ADDENDUM NO. 2

BID NO. 2023-011

CITY OF MARGATE LIFT STATION NO. 20

OPTIONAL VERTICAL
MOUNTING ORIENTATION
(RAIN SHIELD REQUIRED)
PN# 4-1800FAPC-R

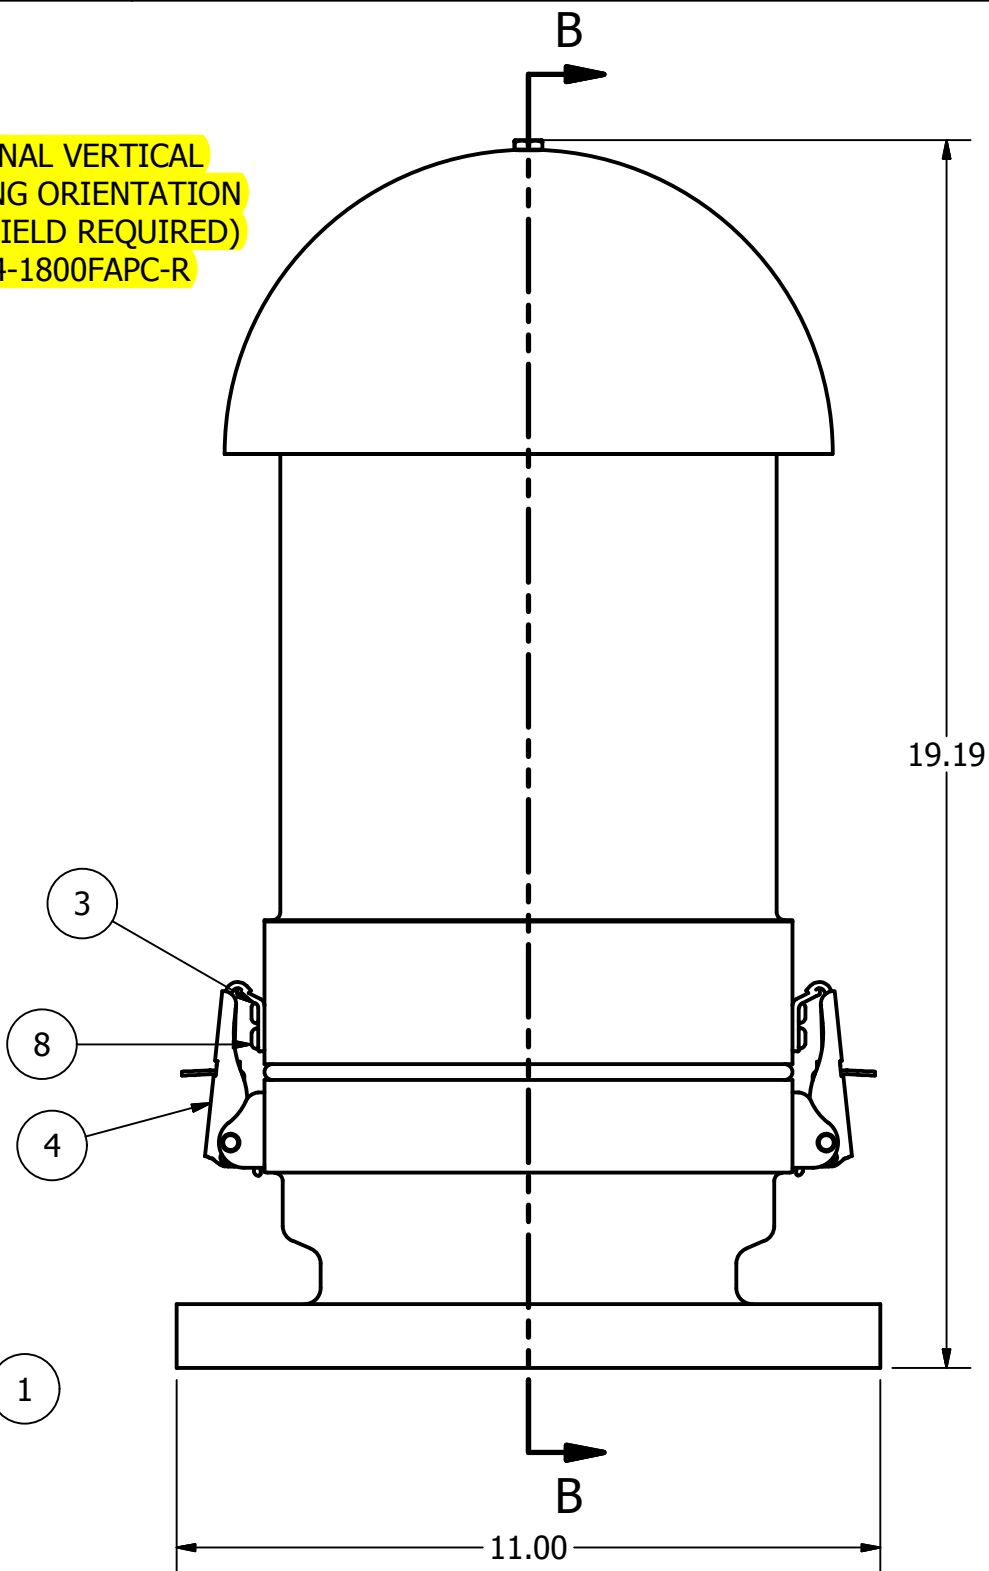
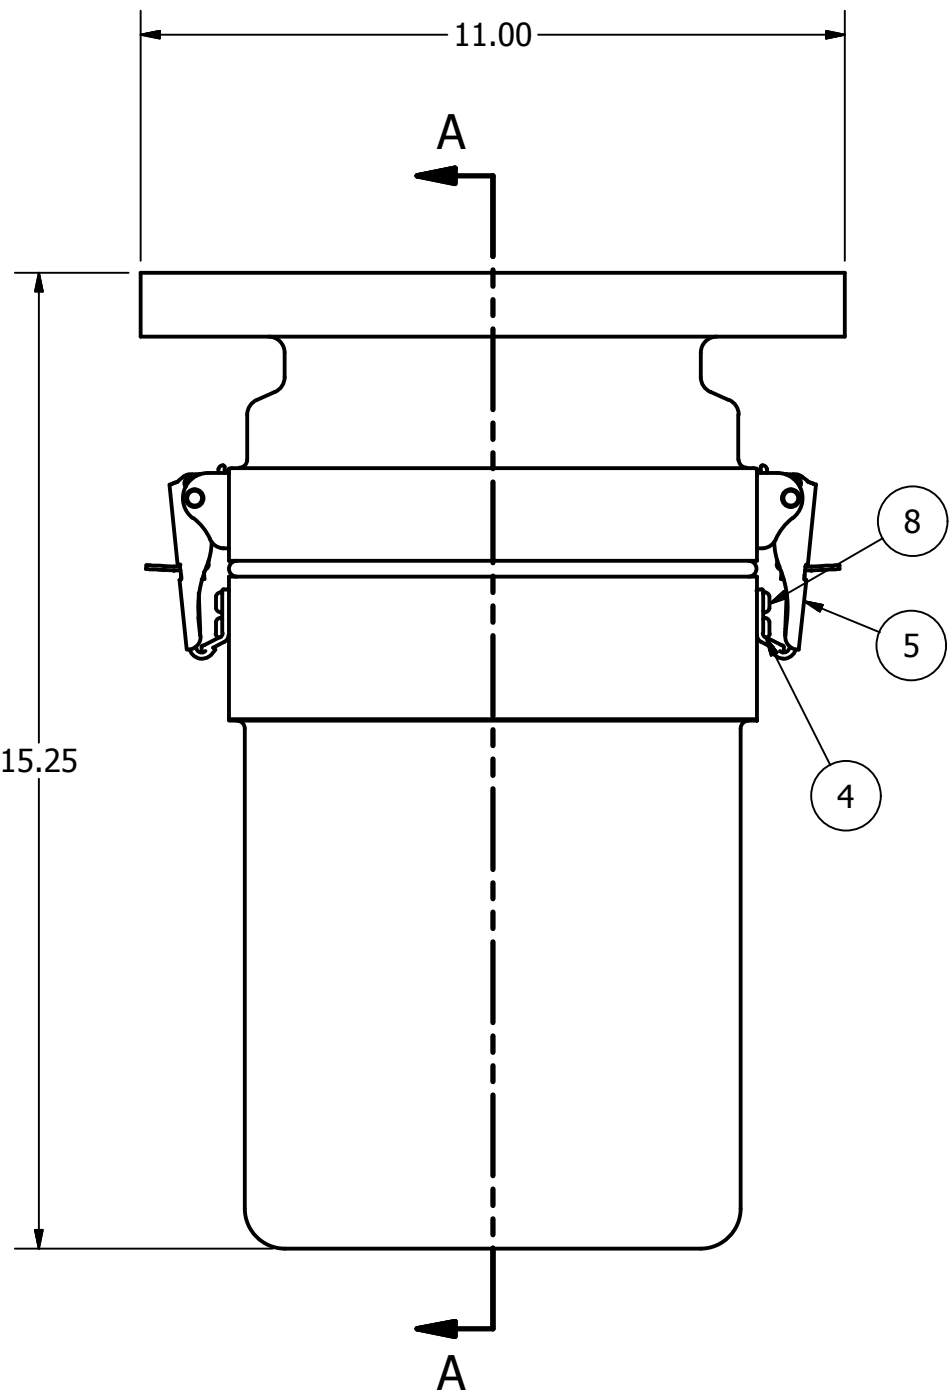
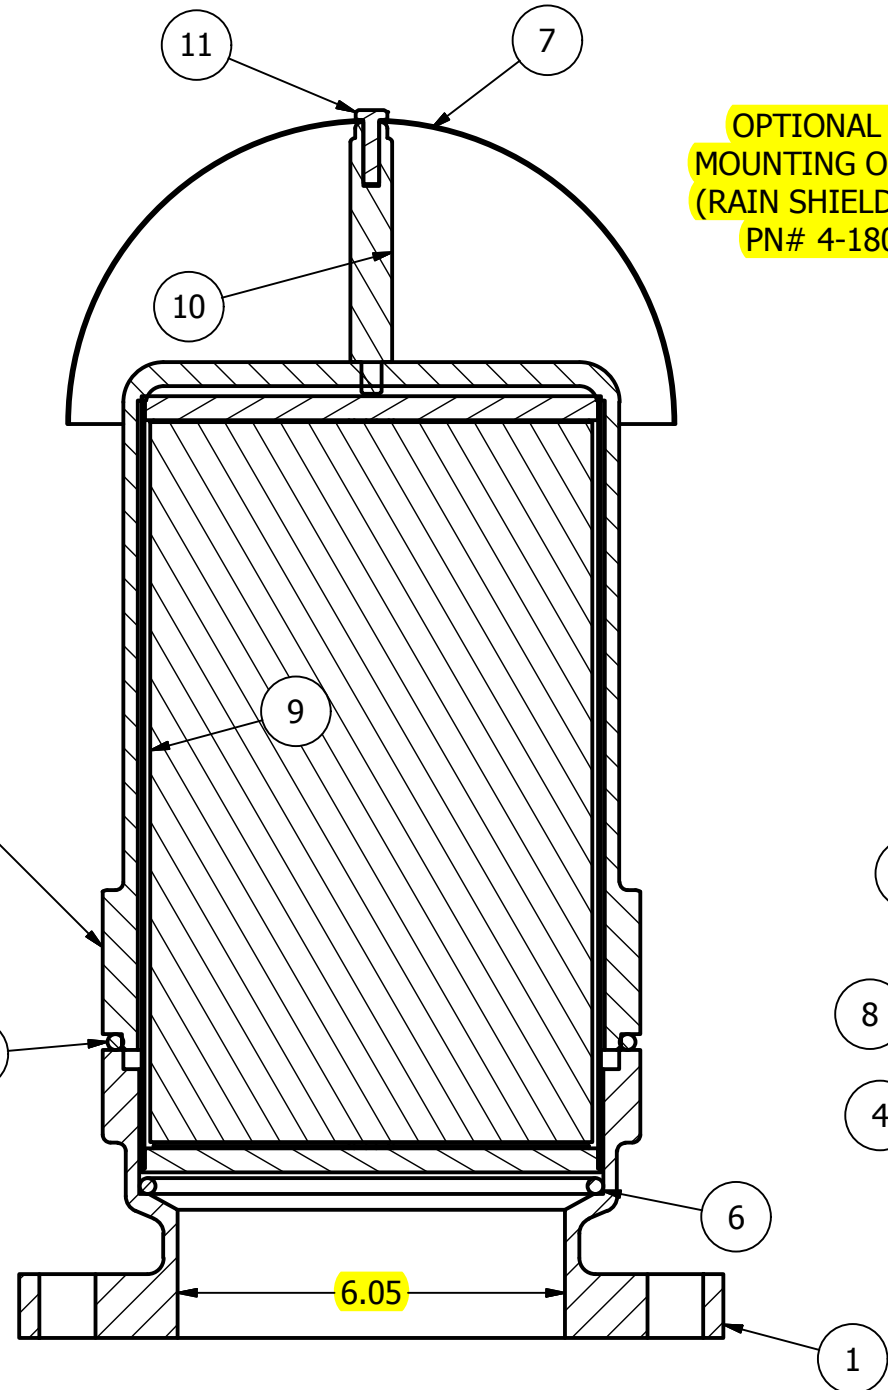
1. Bidders are to replace the proposed "PV150 Purafil Vent Scrubber" product specified in the "Vent and Anti-Odor/Gas Scrubber Detail" on Sheet C-06 with the Wagner 1800 Vent Scrubber, 6-1800FAPC-R (vertical mount with rain shield). We are having to do this because the specified product is no longer available
2. Remove all references to PV150 Purafil Vent Scrubber and replace with attached Wagner 1800 Odor Control product sheet for referencing.
